GSGNY Bid Addendum Two (2)

Date: 8 July 2022

Project Name: Girl Scouts of Greater New York (GSGNY)

Project Number: 2005

KEY PLAN

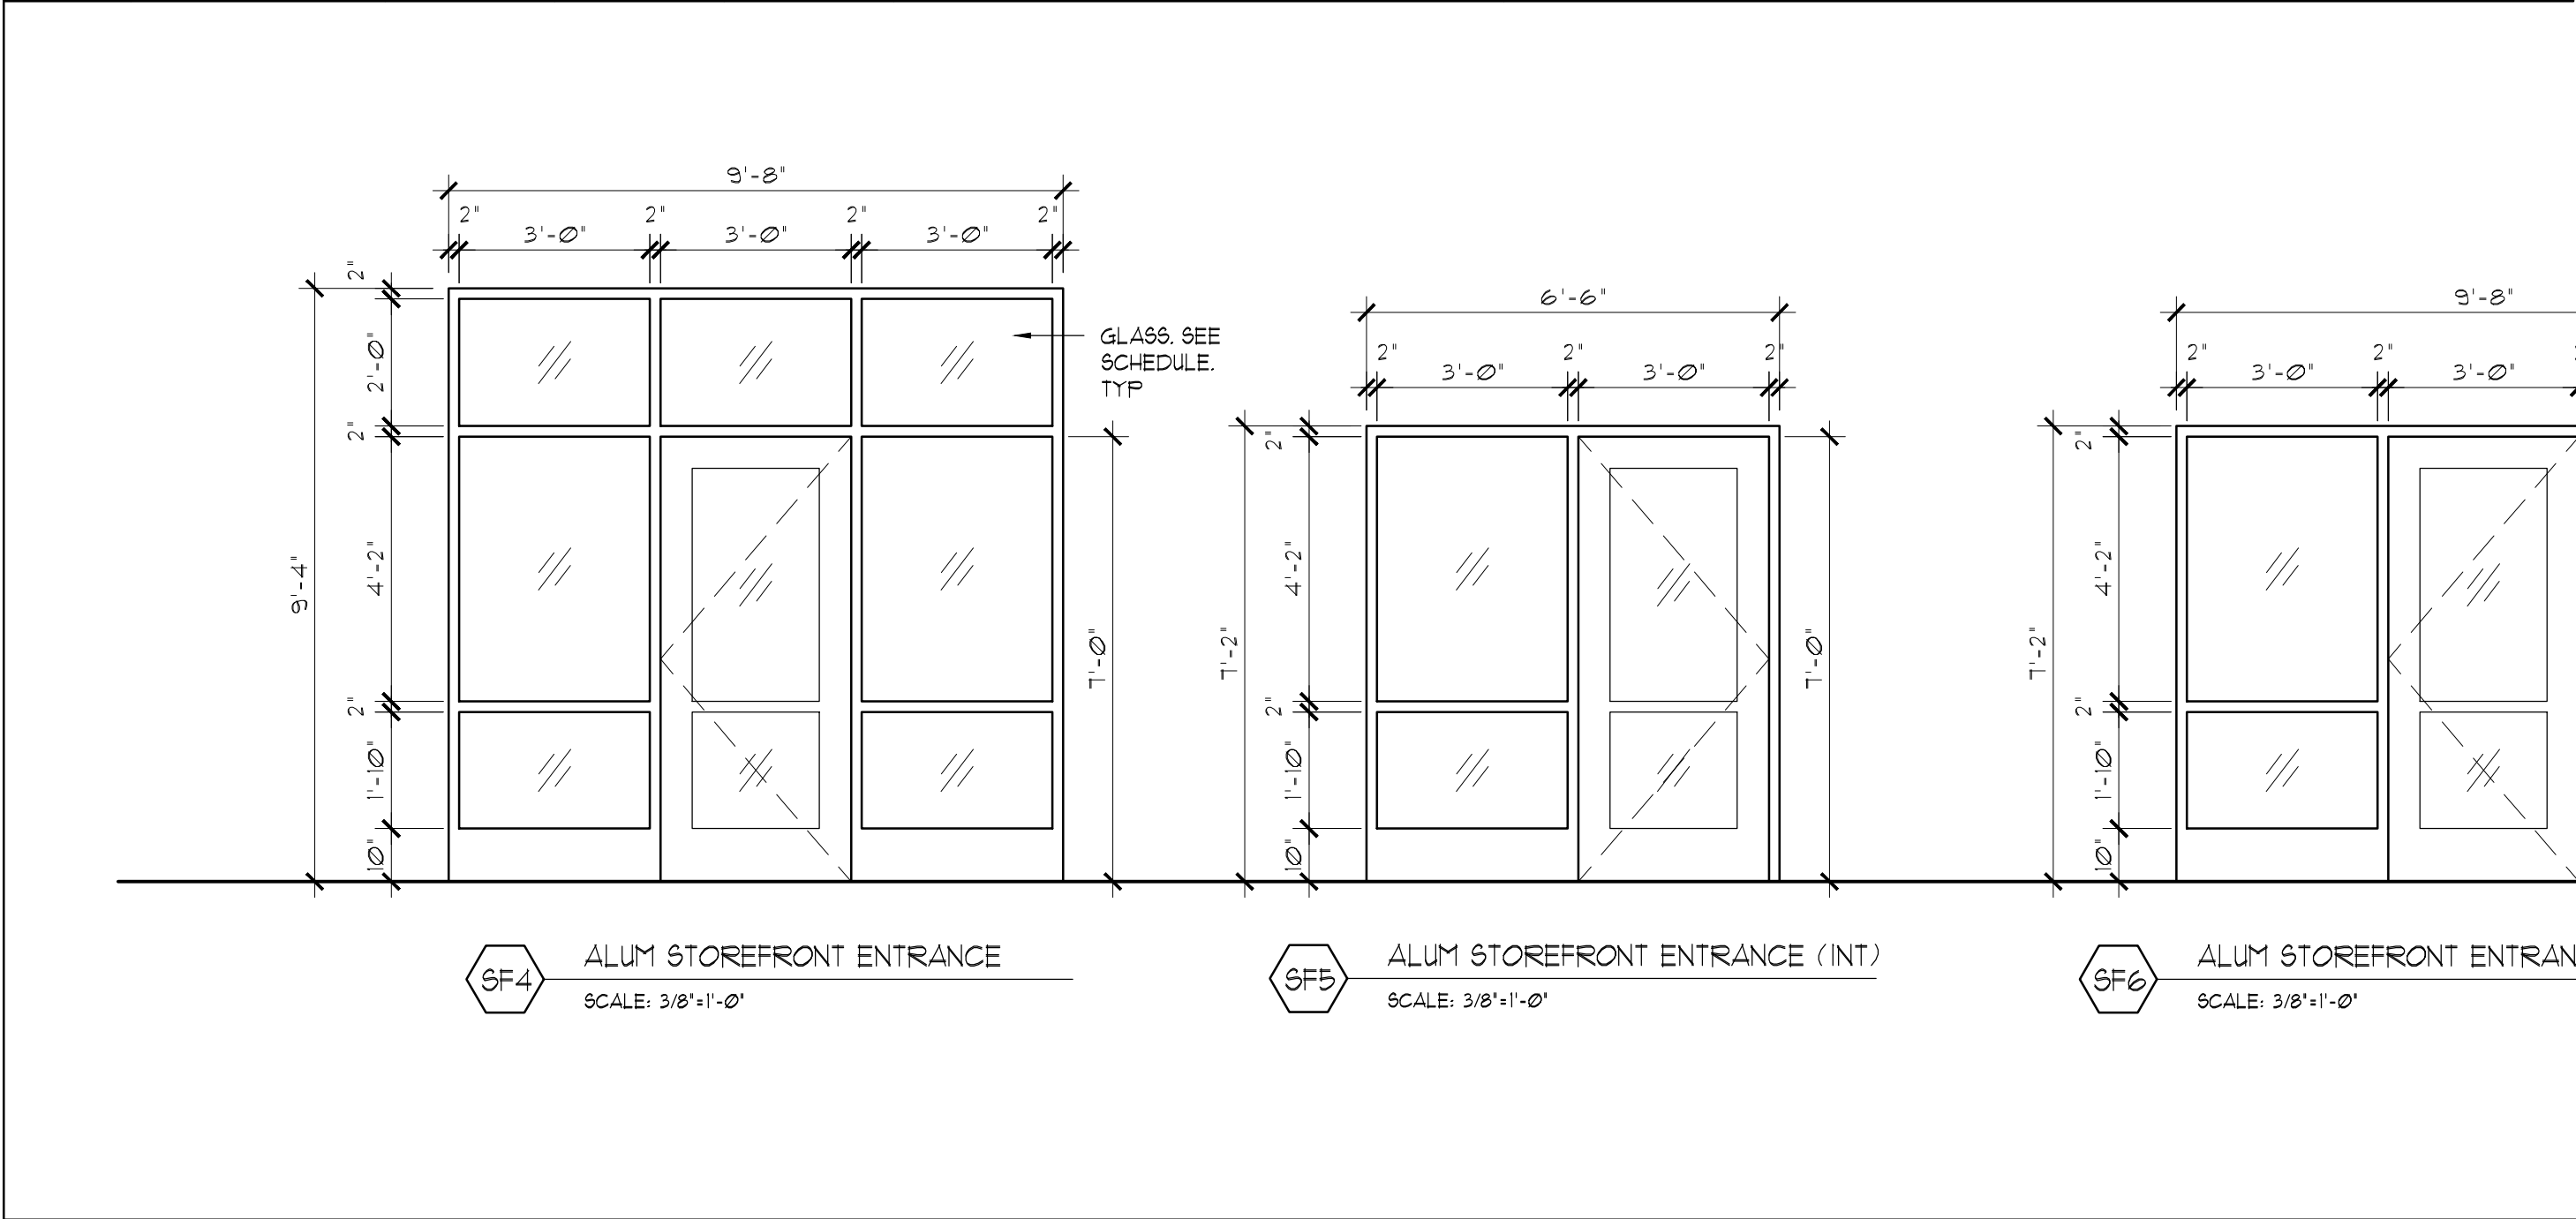
2. **Exterior Glazing:** In order to meet the Performance Criteria required by the Energy Analysis, all glazing in the exterior storefront and exterior aluminum doors, identified as GL-2 on A-900 and A-901, shall be as follows. This Specification supersedes all other descriptions in the Drawings or Specifications. The outdoor lite shall be ¼" clear tempered glass with a Solarban 60 coating on the #2 surface. The ½" airspace shall be filled a 95% argon and 5% air mix. The Indoor lite shall be ¼" clear tempered glass with an Energy Select 73 coating on the #4 surface. The performance ratings are as follows: U = 0.20, SHGC = 0.37 and VTL = 66%.

4. Door #101/ Aluminum Storefront Entrance SF-3: due to the height of the doors, the Specification for this opening only shall be changed from the Kawneer 500 Standard Entrance Door to the Kawneer 2 ¼" Series 500T Insulpour Entrance Door.
